Access Compliance Report

Public Rights-of-Way

(Curb Ramps)

Intersection ID: 54465	Main Street: RUPELL_DR	Cross Street: COLLINGHAM_DR	Location: NE
ADA ID: 620FFB5E58D0	Ramp Type: BlendTrans1	Initial Pass/Fail: Fail	Overall Compliance: No
		Severity Score: 10

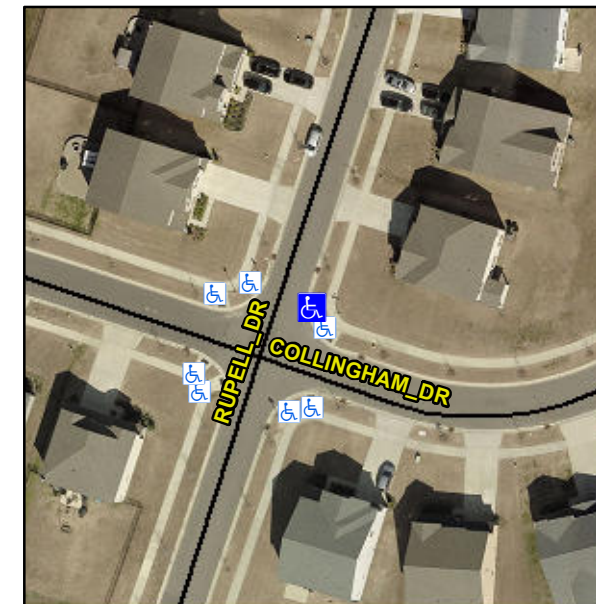
Not Found, R304.5.1, R304.5.3

Compliance	Description	Data	Compliance	Description	Data
N/A	Ramp Length (in)	97.0	Yes	BlendTrans Slope (%)	3.2
No	Ramp Width (in)	45.5	No	BlendTrans XSlope (%)	3.5
N/A	Flare Type LT	N/A	N/A	Flare Type RT	N/A
N/A	Flare Slope LT (%)	N/A	N/A	Flare Slope RT (%)	N/A
N/A	Flare Traversable LT?	N/A	N/A	Flare Traversable RT?	N/A
N/A	Landing Length (in)	N/A	N/A	DWS Provided?	N/A
N/A	Landing Width (in)	N/A	N/A	DWS Contrast?	N/A
N/A	Landing Slope (%)	N/A	N/A	DWS Length (in)	N/A
N/A	Landing X Slope (%)	N/A	N/A	DWS Full Width?	N/A
N/A	Landing Curb? (Y/N)	N/A	N/A	DWS Offset (in)	N/A
N/A	Shared Landing?	N/A			
N/A	Gutter Ponding?	N/A	N/A	Gutter Slope (%)	N/A
N/A	Gutter Lip Ht (in)	0.5	N/A	Gutter X Slope (%)	N/A
N/A	Painted X Walk1?	No	N/A	Painted X Walk2?	N/A
	X Walk 1 Direction	To NW		X Walk 2 Direction	N/A
	X Walk 1 Width (in)	N/A		X Walk 2 Width (in)	N/A
	X Walk 1 Slope (%)	4.5		X Walk 2 Slope (%)	N/A
	X Walk 1 X Slope (%)	1.2		X Walk 2 X Slope (%)	N/A

N/A	Ramp inside XWalk1?	N/A	N/A	Ramp inside XWalk2?	N/A
	Road Slope (%)	1.2		Clear Space?	N/A
	Road X Slope (%)	4.5	N/A	Clear Space to XWalk (in)	N/A
N/A	Any Obstructions?	N/A	N/A	Storm Grate/Utility Hazard?	N/A
	Obstruction Type			Storm Grate/Utility Type	
		N/A			N/A
			Yes	Surface Condition? (G/P)	Good
			No	Curb Slope (%)	15.9

Remove & Replace Curb Ramp With Two New Directional Ramps or Equivalent.
